Access Compliance Report

Public Rights-of-Way

(Curb Ramps)

Intersection ID: 23832	Main Street: KIBWORTH_LN	Cross Street: WAGONFORD_LN	Location: S
ADA ID: 2F1E896022CF	Ramp Type: Perp	Initial Pass/Fail: Fail	Overall Compliance: No
Severity Score: 12.5			
Codes/Mitigation Info/Possible Solution		Field Measurements/Component Compliance

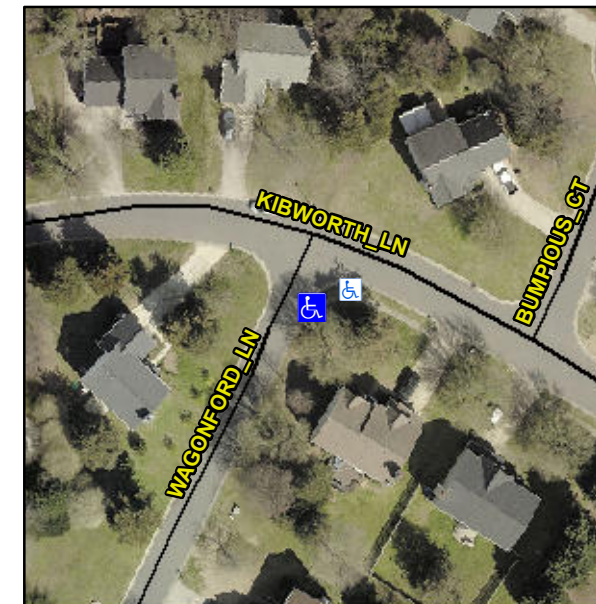
R304.2.2

Compliance	Description	Data	Compliance	Description	Data
N/A	Ramp Length (in)	45.0	No	Ramp Slope (%)	8.9
Yes	Ramp Width (in)	91.0	Yes	Ramp XSlope (%)	0.8
N/A	Flare Type LT	N/A	N/A	Flare Type RT	N/A
N/A	Flare Slope LT (%)	N/A	N/A	Flare Slope RT (%)	N/A
N/A	Flare Traversable LT?	N/A	N/A	Flare Traversable RT?	N/A
N/A	Landing Length (in)	N/A	N/A	DWS Provided?	N/A
N/A	Landing Width (in)	N/A	N/A	DWS Contrast?	N/A
N/A	Landing Slope (%)	N/A	N/A	DWS Length (in)	N/A
N/A	Landing X Slope (%)	N/A	N/A	DWS Full Width?	N/A
N/A	Landing Curb? (Y/N)	N/A	N/A	DWS Offset (in)	N/A
N/A	Shared Landing?	N/A			
N/A	Gutter Ponding?	N/A	N/A	Gutter Slope (%)	N/A
N/A	Gutter Lip Ht (in)	N/A	N/A	Gutter X Slope (%)	N/A
N/A	Painted X Walk1?	No	N/A	Painted X Walk2?	N/A
	X Walk 1 Direction	To NW		X Walk 2 Direction	N/A
N/A	X Walk 1 Width (in)	N/A	N/A	X Walk 2 Width (in)	N/A
	X Walk 1 Slope (%)	3.8		X Walk 2 Slope (%)	N/A
	X Walk 1 X Slope (%)	2.3		X Walk 2 X Slope (%)	N/A

Remove & Replace Entire Ramp.
